UNITED STATES PATENT AND TRADEMARK OFFICE

APPLICATION NO.	FILING DATE	FIRST NAMED INVENTOR	ATTORNEY DOCKET NO.	CONFIRMATION NO.
09/680,277	10/06/2000	Je Hong Kim	2658-0242P	8486

Office Action Summary

FIG. 1

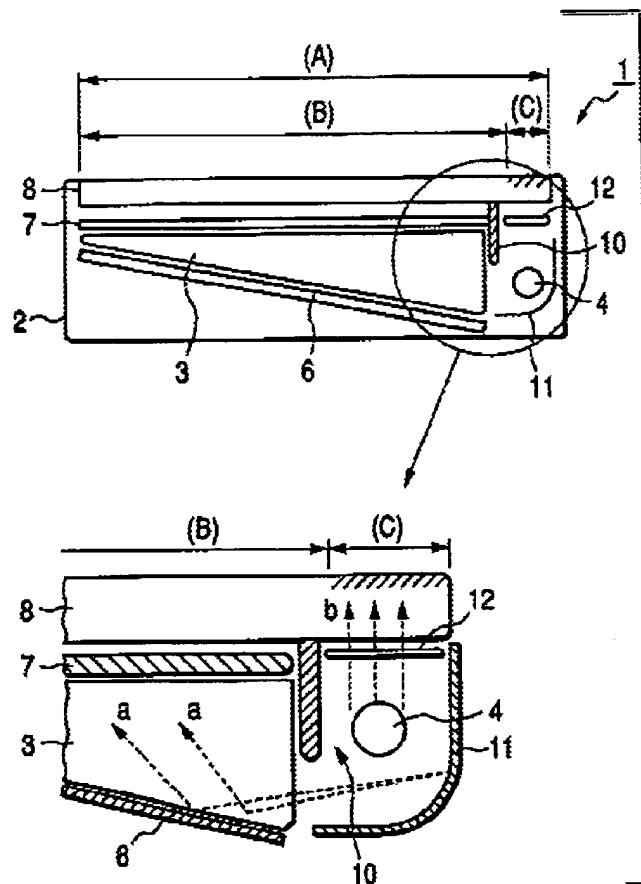
Matsushita teaches in the first embodiment, Figure 1, the use of a light input device wherein a light shielding plate, 10, is disposed so that part of the light emitted from the linear light source and reflected by the reflecting plate, 11, is condensed

(Applicant's high focusing) at the end portion (col. 6, lines 22-29) of the light conduction plate, 3 (Applicant's light guide), in order to improve display visibility so the LCD can be formed as a vehicle-mounted alarm display device for displaying various alarms (Abstract). As can be seen in Figure 1, the light is substantially directed to a rear side of said light input device in a direction away from the light guide prior to directing said light path to a front side thereof and toward the light guide to obtain high focusing of the light beam.

Matsushita is evidence that ordinary workers in the art of liquid crystals would find the reason, suggestion, or motivation to add a light input device wherein a light shielding plate is disposed so that part of the light emitted from the linear light source

and reflected by the reflecting plate is condensed (Applicant's high focusing) at the end portion of the light conduction plate in order to improve display visibility so the LCD can be formed as a vehicle-mounted alarm display device for displaying various alarms.

Therefore, it would have been obvious to one having ordinary skill in the art of liquid crystals at the time the invention was made to modify the LCD of APA by directing a light path of a light beam substantially to a rear side of said light input device in a direction away from the light guide prior to directing said light path to a front side thereof and toward the light guide to obtain high focusing of the light beam of Matsushita in order to improve display visibility so the LCD can be formed as a vehicle-mounted alarm display device for displaying various alarms.

FIG.4

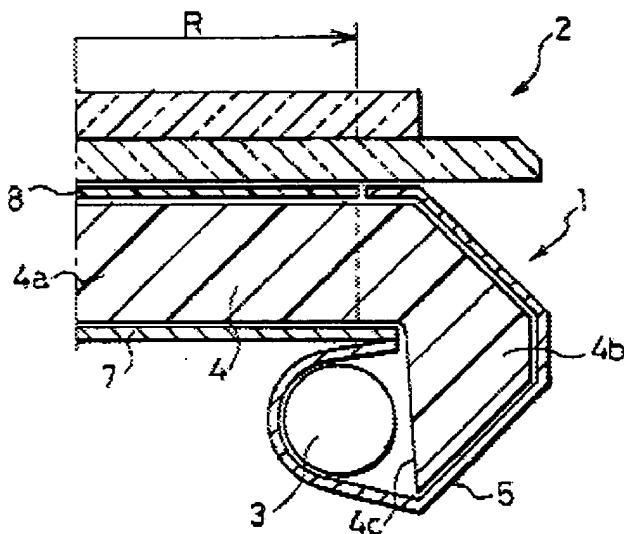
Oyama teaches in Figure 4 a light unit comprising a light-guide plate, 4a, and a reflector, 5, having a sectional view of spiral shape that efficiently guides the light (Applicant's high focus) from the light source to the light guide plate (col. 6, lines 13-24).

Oyama teaches in Figure 4 a light-guide plate, 4a, installed at height different from the light, 3, input to reduce the outside dimensions of the entire apparatus with respect to the area of the display space (col. 2, lines 53-60) having a sectional view of spiral shape. Note this motivation is applicable regardless of element 4b.

Oyama is evidence that ordinary workers in the art of liquid crystals would find the reason, suggestion, or motivation to add a light-guide plate installed at height different from the light input to reduce the outside dimensions of the entire apparatus with respect to the area of the display space.

Therefore, it would have been obvious to one having ordinary skill in the art of liquid crystals at the time the invention was made to modify the LCD of APA in view of Matsushita with the light-guide plate installed at height different from the light input of Oyama.

FIG.14(b)

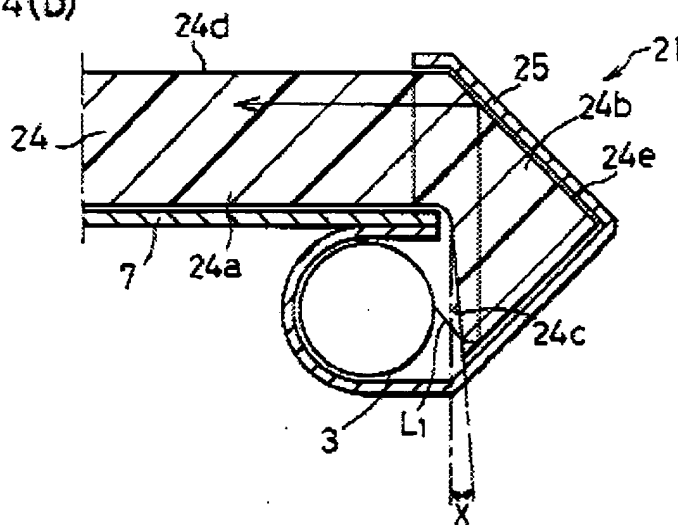
As to claim 5, Oyama teaches in Figure 14(b) a light unit wherein the reflective plate, 25, is curved to obtain a desired vertical incident angle of the light beam progressing to the light-guide plate to reduce bright lines in the display near the light source (col. 13, lines 33-52, especially lines 42-48).

Oyama is evidence that ordinary workers in the art of liquid crystals would find the reason, suggestion, or motivation to use a light unit wherein the reflective plate is curved to obtain a desired vertical incident angle of the light beam progressing to the light-guide plate to provide desired illumination characteristics.

Therefore, it would have been obvious to one having ordinary skill in the art of liquid crystals at the time the invention was made to modify the LCD of APA in view of Matsushita with the curved reflective plate of Oyama.

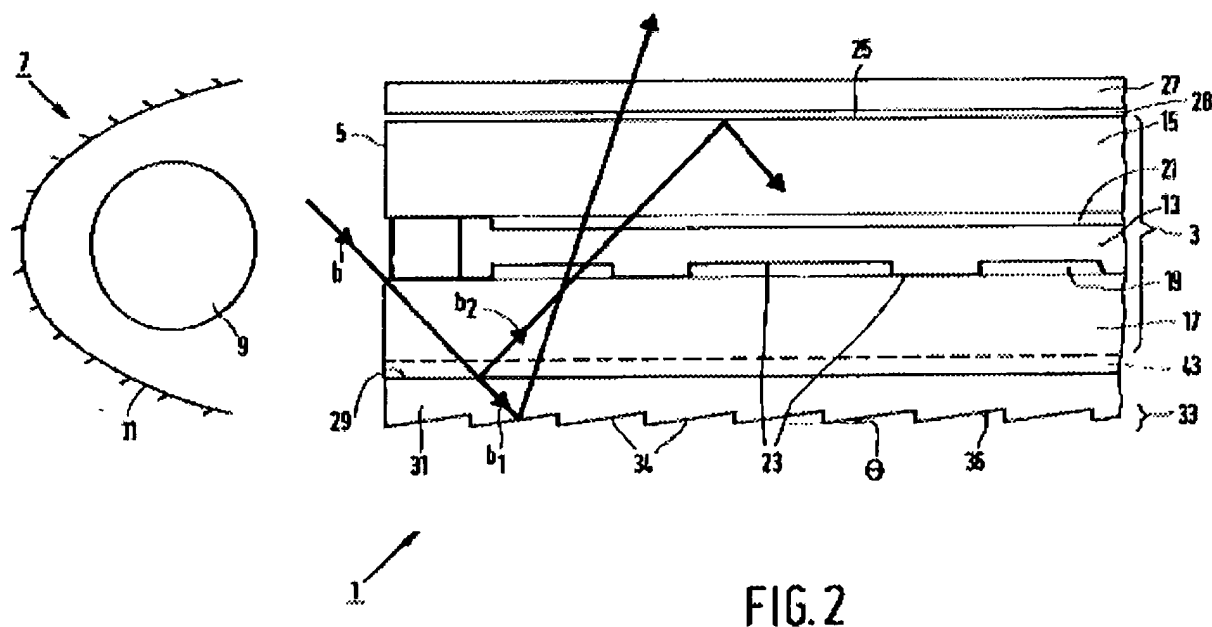
As to claim 7, Oyama teaches in Figure 14(a) a light unit wherein the lamp housing includes at least one reflective plate for cutting off the light beam progressing directly from the lamp into the light-guide plate, the at least one reflective plate being a protrusion of the inner surface of the lamp housing.

Oyama is evidence that ordinary workers in the art of liquid crystals would find the reason, suggestion, or motivation to use a reflective plate for cutting off the light beam progressing directly from the lamp into the light-guide plate, the at least one reflective plate being a protrusion of the inner surface of the lamp housing to provide desired illumination characteristics.

Therefore, it would have been obvious to one having ordinary skill in the art of liquid crystals at the time the invention was made to modify the LCD of APA in view of Matsushita with the protruding reflective plate of Oyama.

FIG. 7

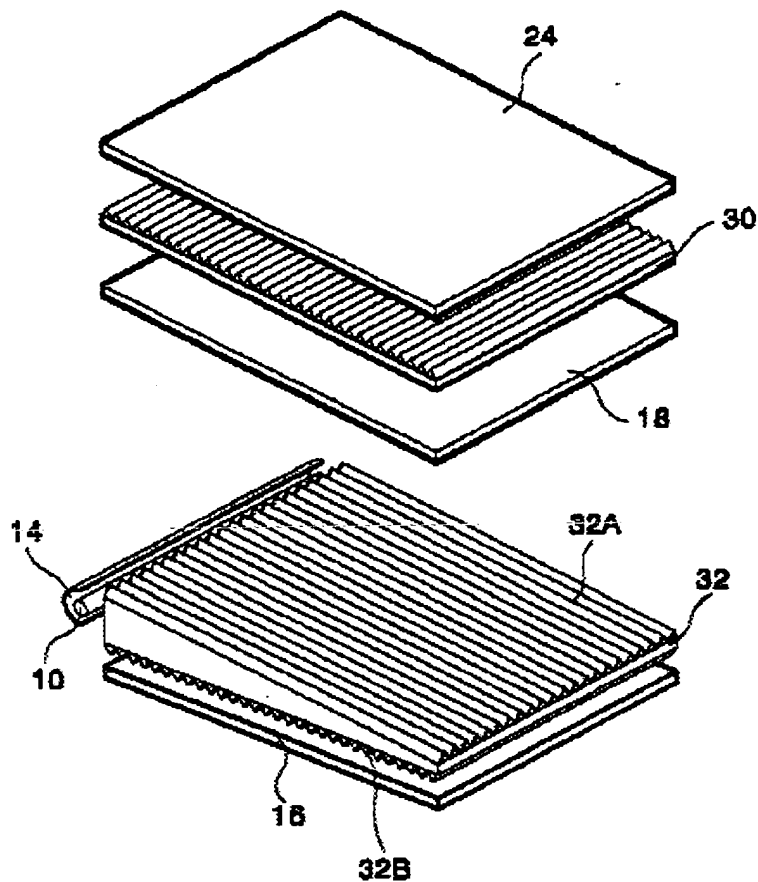
Kim teaches in Figure 7 the use of a light unit wherein the light-guide plate includes a plurality of prism patterns arranged on another surface thereof in intersection with the unit patterns.

Kim is evidence that ordinary workers in the art of liquid crystals would find the reason, suggestion, or motivation to add a plurality of prism patterns arranged on another surface thereof in intersection with the unit patterns to enhance the utilization ratio of the light generated by the lamp (col. 6, line 58 through col. 7, line 15).

Therefore, it would have been obvious to one having ordinary skill in the art of liquid crystals at the time the invention was made to modify the LCD of APA in view of Matsushita and Broer with the plurality of prism patterns arranged on another (upper) surface of the light guide plate of Kim.

FIG. 1

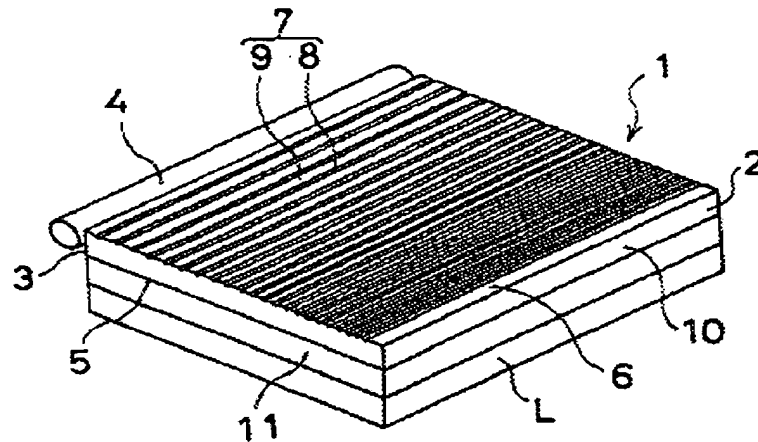
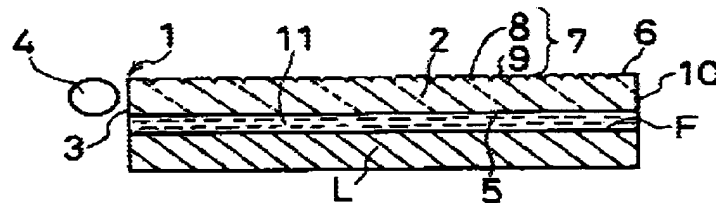
Egawa teaches in Figures 1 and 2 a light guide plate dispose on the front side of a liquid crystal panel to provide illumination without degrading contrast and without generating a moiré pattern (col. 4, lines 11-17).

Egawa is evidence that ordinary workers in the art of liquid crystals would find the reason, suggestion, or motivation to add a light guide plate disposed on the front side of a liquid crystal panel to provide illumination without degrading contrast and without generating a moiré pattern.

Therefore, it would have been obvious to one having ordinary skill in the art of liquid crystals at the time the invention was made to modify the LCD of APA in view of Matsushima and Broer with the light guide plate disposed on the front side of a liquid crystal panel of Egawa.

Egawa teaches in Figures 1 and 2 a light guide plate wherein a distance between the unit patterns that gets gradually shorter as said unit patterns get farther away from the incident side of the light-guide plate so that the brightness becomes nearly uniform at any position in the transparent substrate (light guide) without being influenced by the distances from the light source lamp (col. 12, lines 34-50).

Egawa is evidence that ordinary workers in the art of liquid crystals would find the reason, suggestion, or motivation to add a distance between unit patterns that gets gradually shorter as said unit patterns get farther away from the incident side of the light-guide plate so that the brightness becomes nearly uniform at any position in the light guide without being influenced by the distances from the light source lamp.

Therefore, it would have been obvious to one having ordinary skill in the art of liquid crystals at the time the invention was made to modify the LCD of APA in view of Matsushita and Broer with the distance between unit patterns that gets gradually shorter of Egawa.
